PLANNING RATIONALE ADDENDUM #2

3071 RIVERSIDE DRIVE

**RE: 3071 Riverside Drive
Official Plan Amendment and Zoning By-law Amendment Applications**

Figure 2: Proposed Zones

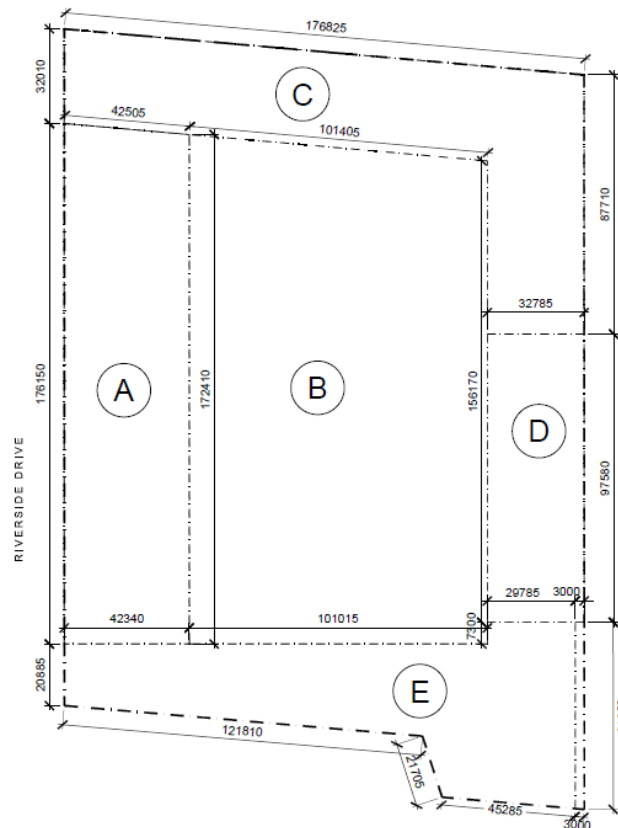
As noted in the original Planning Rationale, the property is presently zoned Minor Institutional Subzone A (I1A). A proposed zoning schedule was previously submitted. It is proposed to further refine the proposed zoning as shown in Figure 2 below.

- AREA 'A' GM [xxx]
- AREA 'B' I1A [xyz]
- AREA 'C' R3 [xxx]
- AREA 'D' R4 [xyz]
- AREA 'E' O1

/ **General Mixed Use (GM) Zone**

- Land uses prohibited:
 - Animal hospital
 - Apartment Dwelling, Mid-Rise
 - Click and collect facility
 - Diplomatic mission
 - Drive-through facility
 - Funeral home
 - Research and development centre
 - Shelter
 - Technology industry
 - Stacked townhouse
- Two loading spaces required in accordance with the following site-specific provisions:

- No oversized loading spaces required.
- Minimum width in metres of aisle accessing loading space – 7 metres.
- No screening required for loading spaces.

/ **Minor Institutional (I1A) Zone**

- Additional Permitted Land Uses
- Planned Unit Development

/ **Residential Third Density (R3) Zone**

- Minimum lot width: 6 metres
- Minimum lot area: 170 square metres

/ **Residential Fourth Density (R4) Zone**

- Minimum lot width: 30 metres
- Minimum lot area: 750 square metres

/ **Parks and Open Space (O1) Zone**

- No minimum setbacks are required

Figure 3: Proposed Building Height and Setbacks

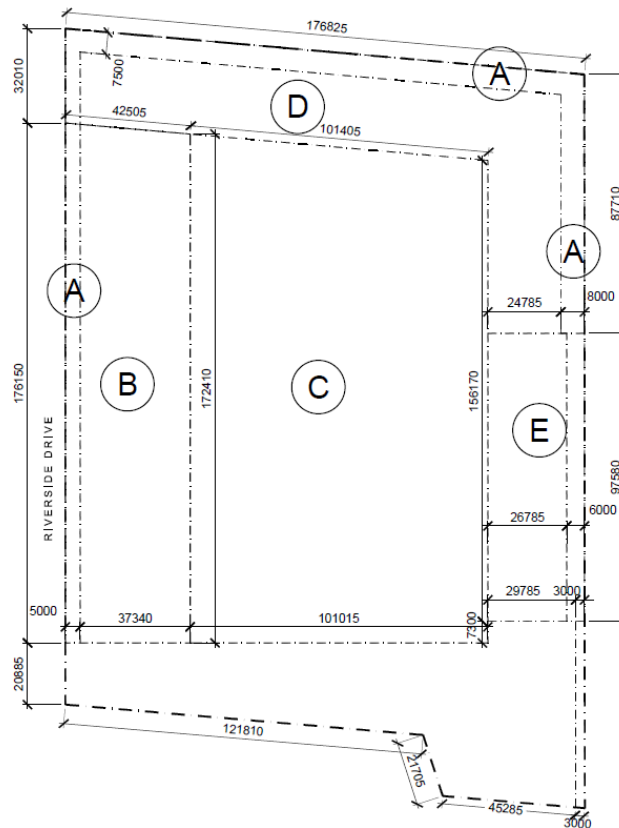
In order to specify the required setbacks and maximum building height, a site-specific zoning schedule is proposed as shown in Figure 3 below. The schedule specifies the maximum building height permitted for various areas throughout the site as well as the setbacks required along Riverside Drive, the northerly property line and the westerly property line.

- AREA 'A' NO BUILDINGS PERMITTED
 AREA 'B' 13.5M - 3 STOREYS
 AREA 'C' 23.0M - 6 STOREYS
 AREA 'D' 8.0M - 2 STOREYS
 AREA 'E' 14.0M - 3.5 STOREYS
